MEMORANDUM

To: Design Review Board
From: Angela Ruggeri, Senior Planner
Date: December 2, 2015
File No.: DRV12-01513
Subject: **KIRKLAND PARKPLACE MIXED USE DEVELOPMENT
DESIGN RESPONSE CONFERENCE (CONTINUED)**

KIRKLAND PARKPLACE

DRC 6 Preliminary package

TREE PLAN | PARK EDGE

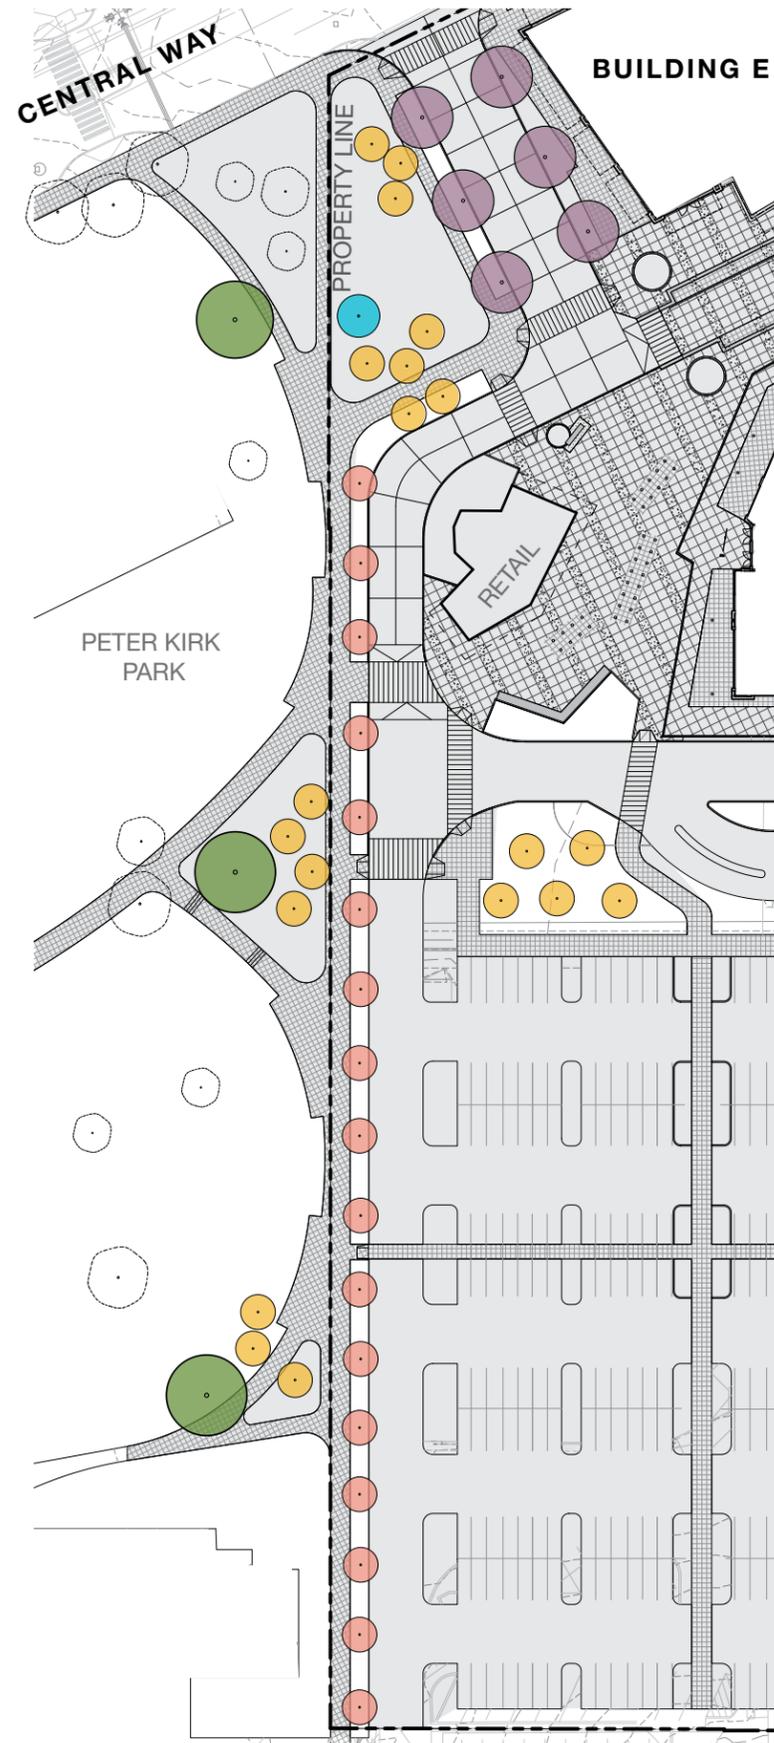
1. Include **pages from Hewitt's previous submittal packages regarding** plaza and street lighting (include proposed street lights and lighting along the park edge)
2. Provide options for vine maples

1. Ensure previous submittal packages regarding plaza and street lighting are included (include the street lights that are proposed and also what lighting is proposed along the park edge)-
[refer to page 11 of DRC 4 \(site lighting\), included here for reference .](#)
2. Provide options for vine maples
[Please see draft revised tree planting](#)

IDENTIFICATION OF ROOFTOP MECHANICAL AREAS

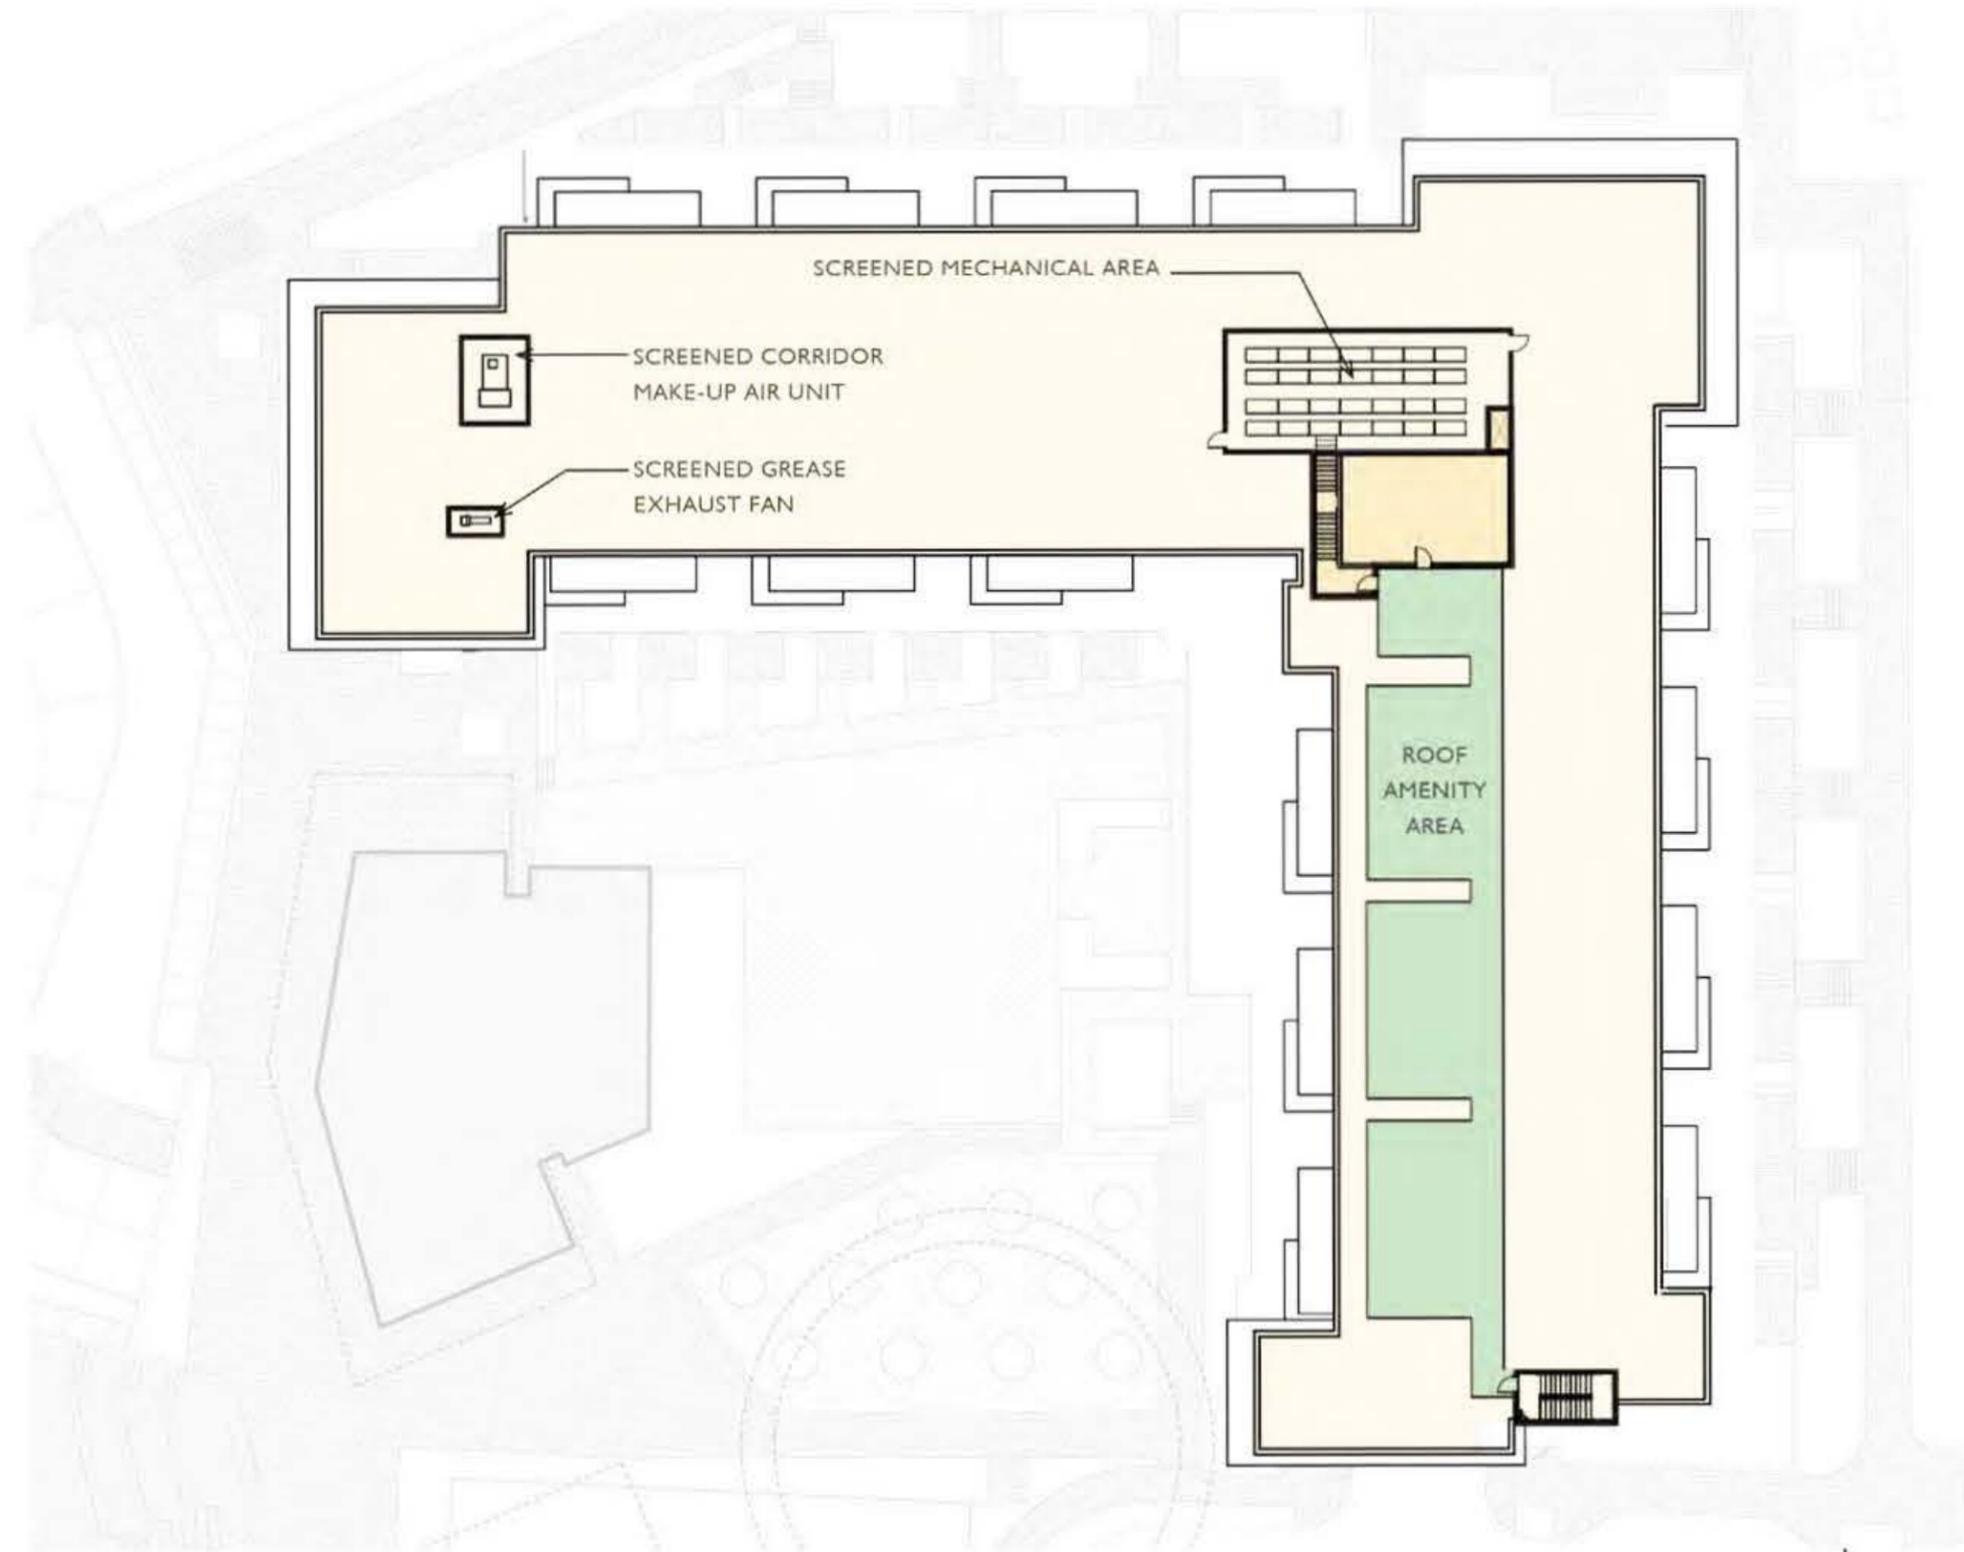
1. Grout color for brick
2. Coping detail at brick soldier course
3. Study of band of light at corner (delete or change?)
4. Soffit and louver details
5. Information on mechanical (show on roof plans and elevations) – keep screening simple.

Residential [Refer to Weber Thompson sheets included](#)
